**STATE LOOP 360**

**CSJ 5000-00-131**

**CONTEXT SENSITIVE SOLUTIONS  
SUMMARY**

## **Loop 360 Context Sensitive Solutions Report June 2019 Workshop and Survey Feedback**

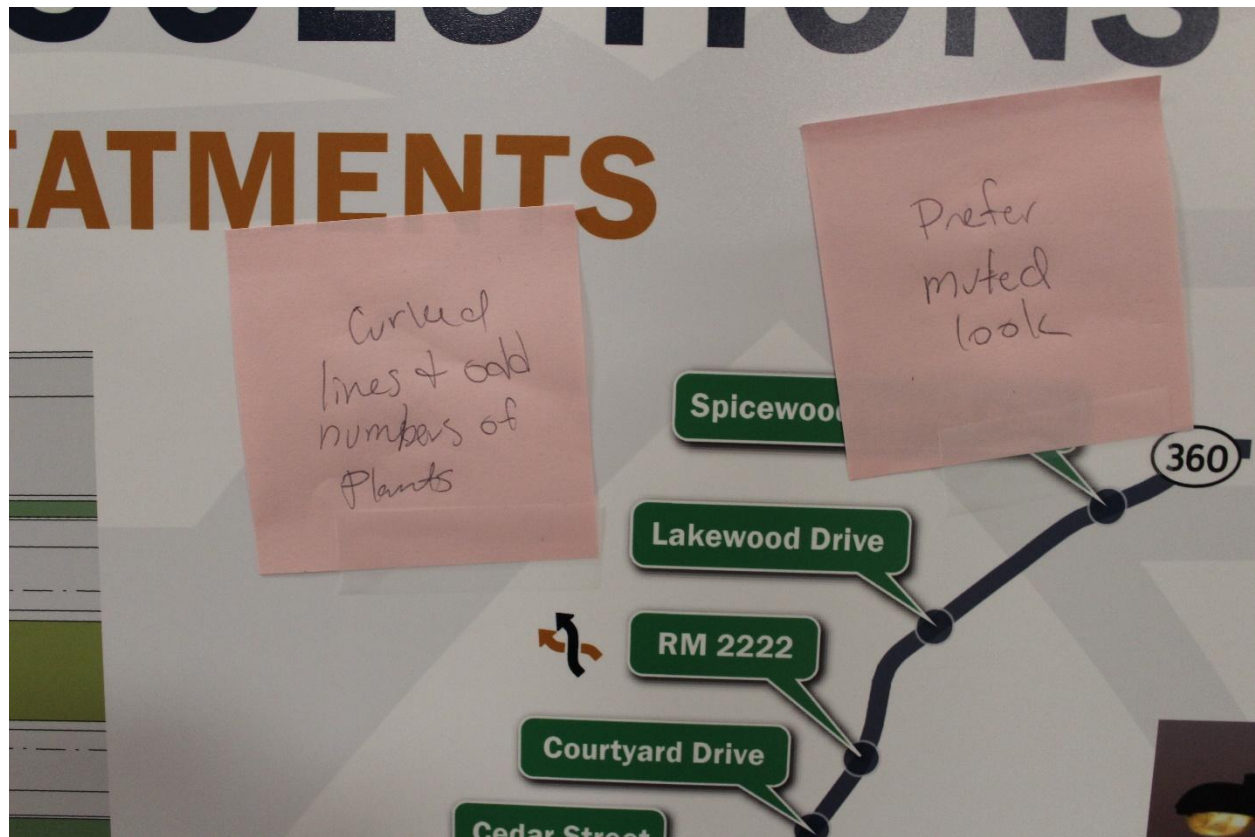
- Consider trees to add numbers to plants
- Sketches of landscape treatments
- Sketch of Cobra head LED lighting
- Sketch of landscape treatment with text: "Landscape by aerial roots keep low to trees/plants"
- Sketch of landscape treatment with text: "More prairie grass landscape"
- Top right: "Cobra head LED lighting for option 1 & 2"

- Sketch of landscape treatment
- Sketch of Cobra head LED lighting
- Sketch of landscape treatment with text: "Landscape by aerial roots keep low to trees/plants"
- Sketch of landscape treatment with text: "More prairie grass landscape"
- Top right: "Cobra head LED lighting for option 1 & 2"

Landscape  
by access roads  
Keep lots of  
trees/plants

Mix  
prairie grass  
with wildflowers

# BRIDGE SUPPORTS

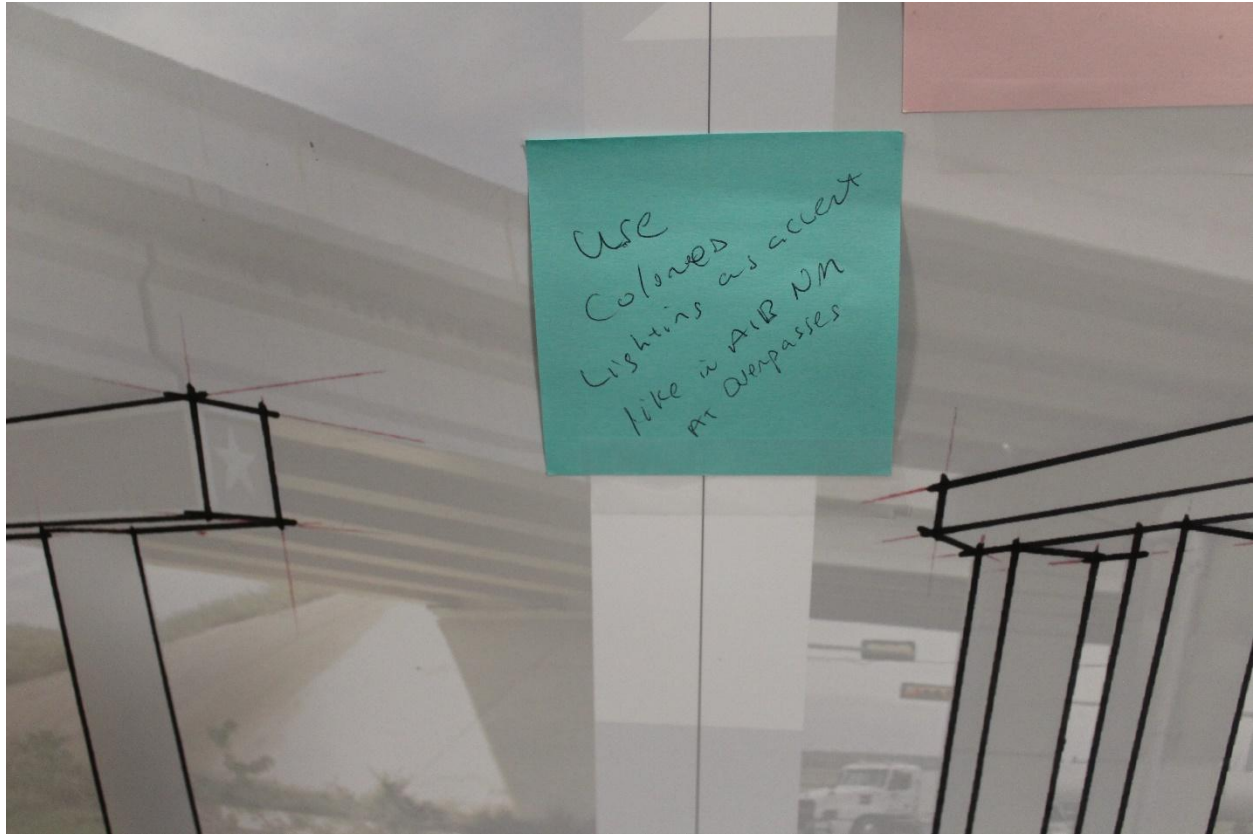
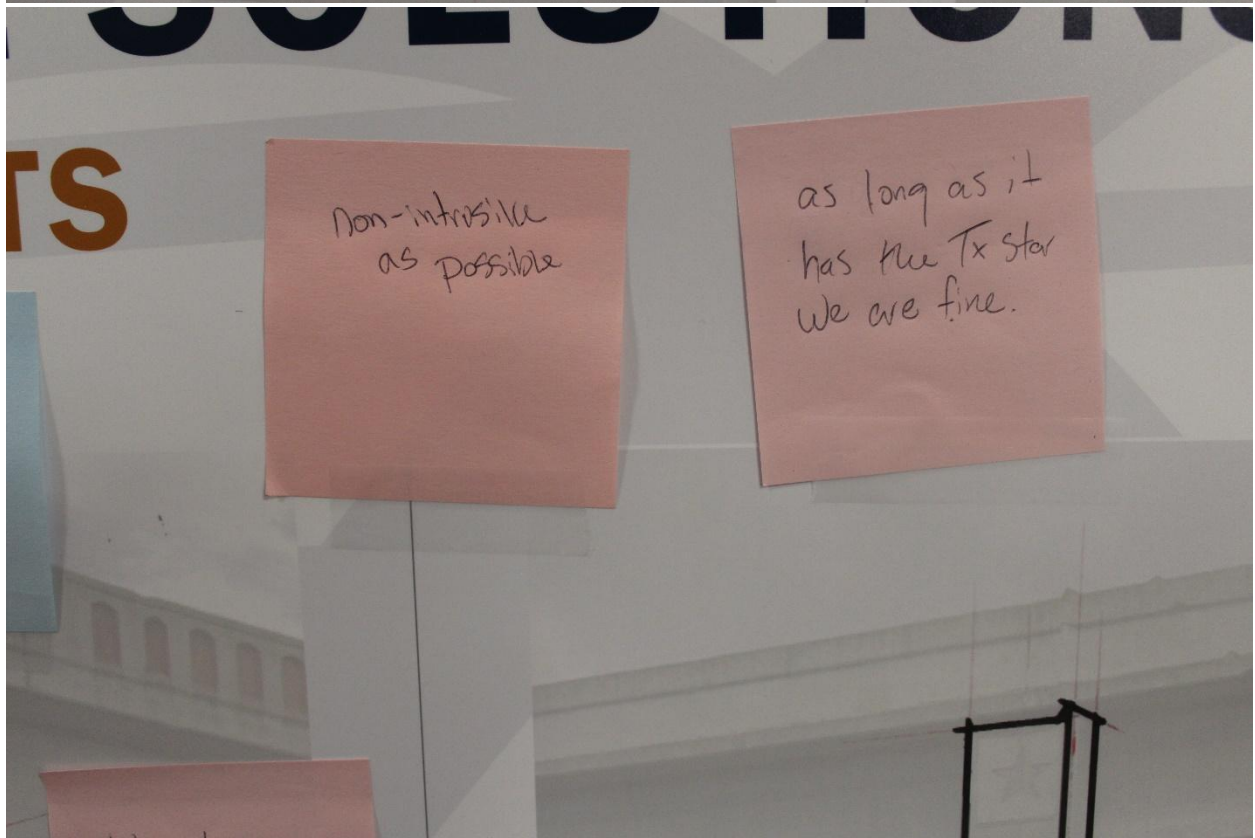
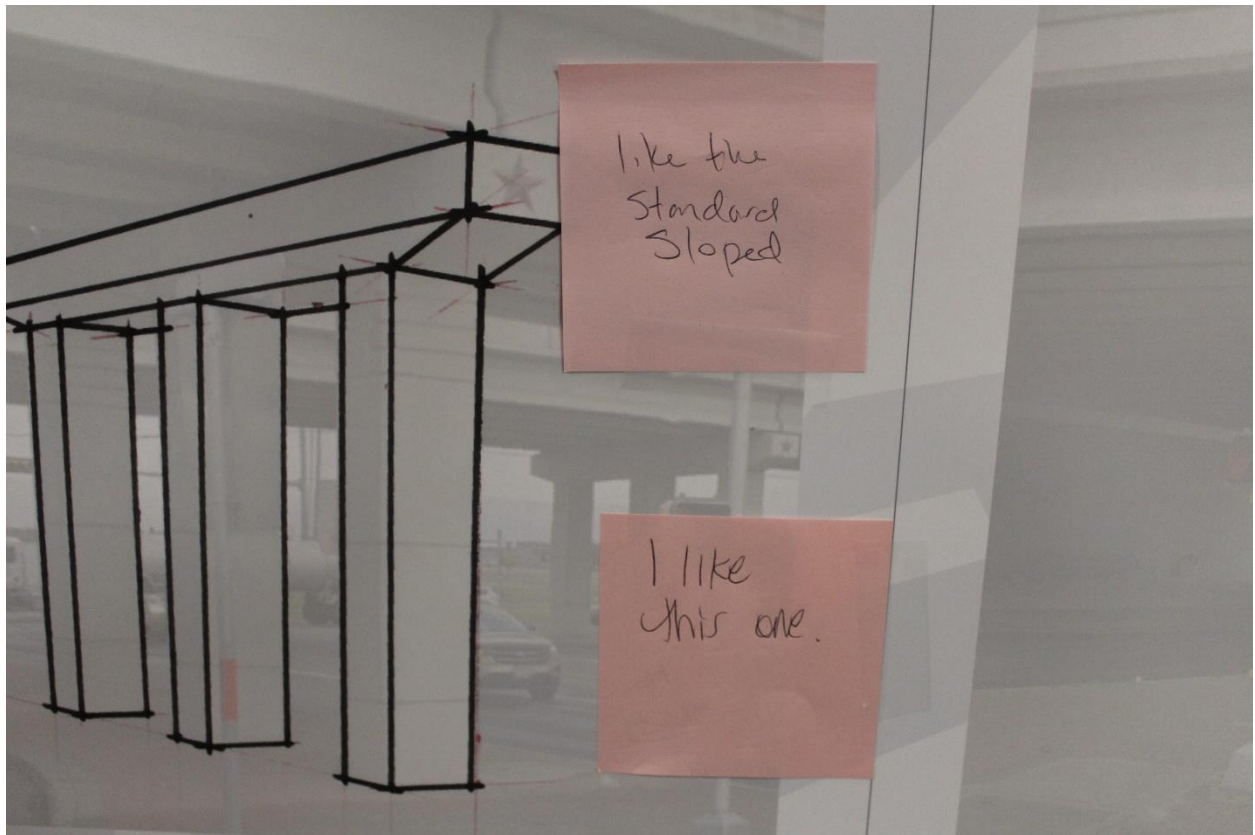
Colors on columns, textures, stone treatment

Use  
Columns as accent  
Lighting as accent  
like in AIR NM  
at overpasses

Like this  
on a  
standard sloped

Bent Cap  
Some TX  
motif would  
be nice

e  
slabs  
lighting as accent  
like in AIR NM  
at overpasses

as it  
Tx star  
fine.

make it look  
like a highway

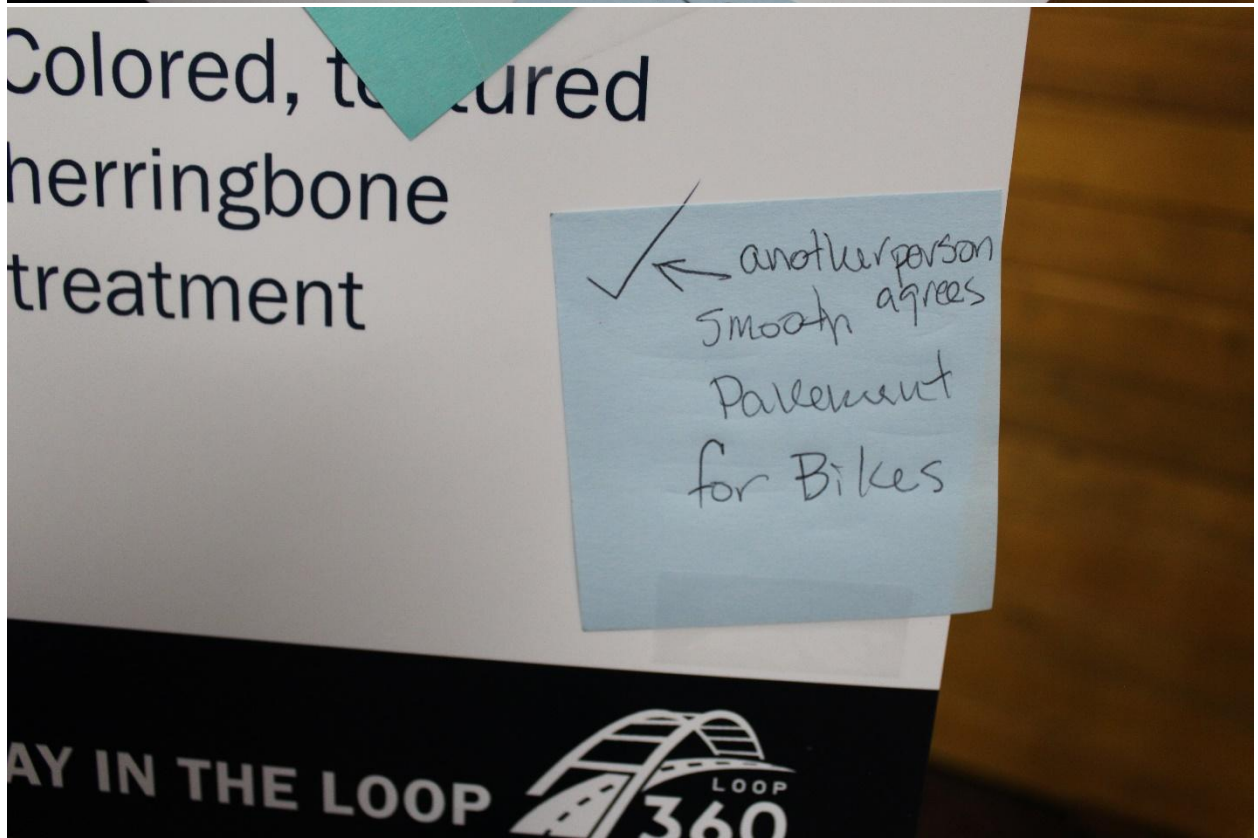
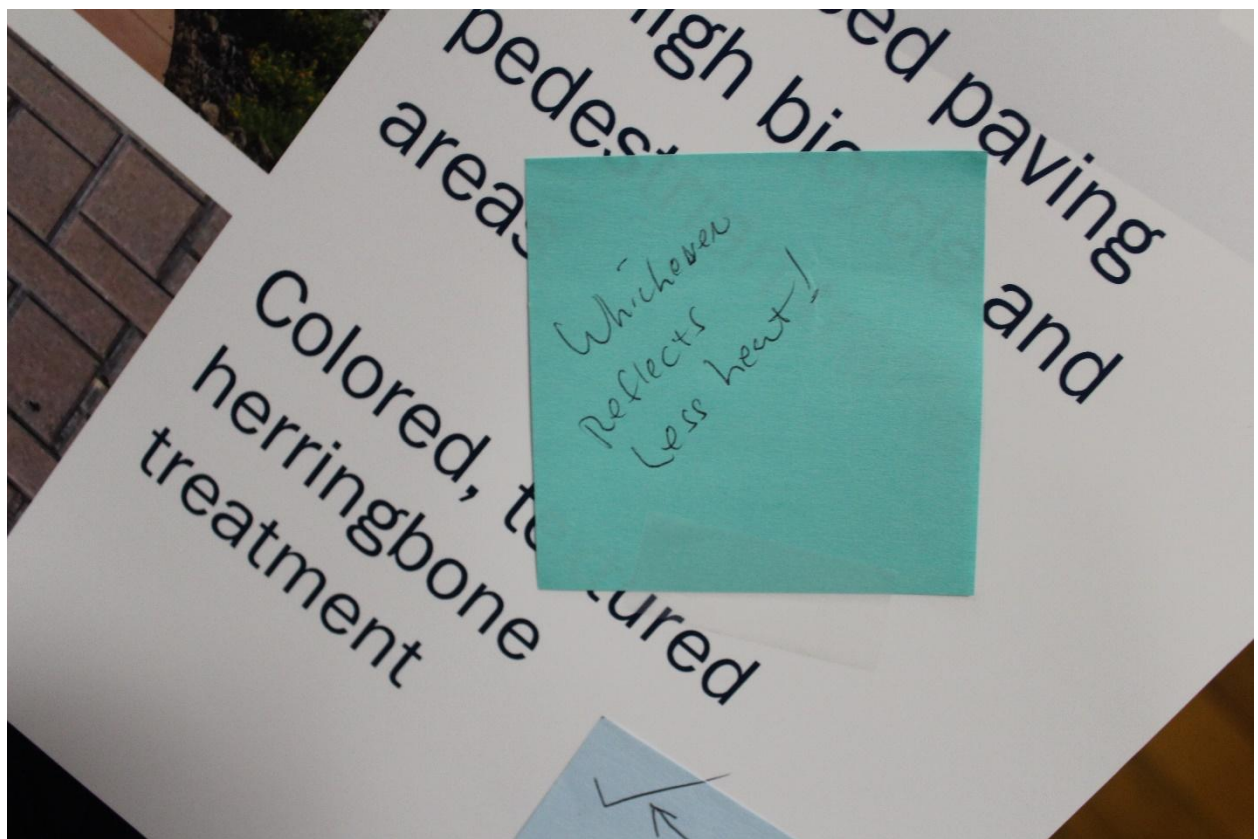
Sound  
Reduction  
w/ pavement

Like keep  
w/ low

Lessen  
Heat island

Lessen  
Heat island  
effect.  
w/ pavement

I strenuously  
object to the proposal  
to use this type  
of design at the  
Courtgard Drive/360  
intersection. It  
destroys the natural  
beauty.

Waste of money  
to pay for  
Peoples Recreation
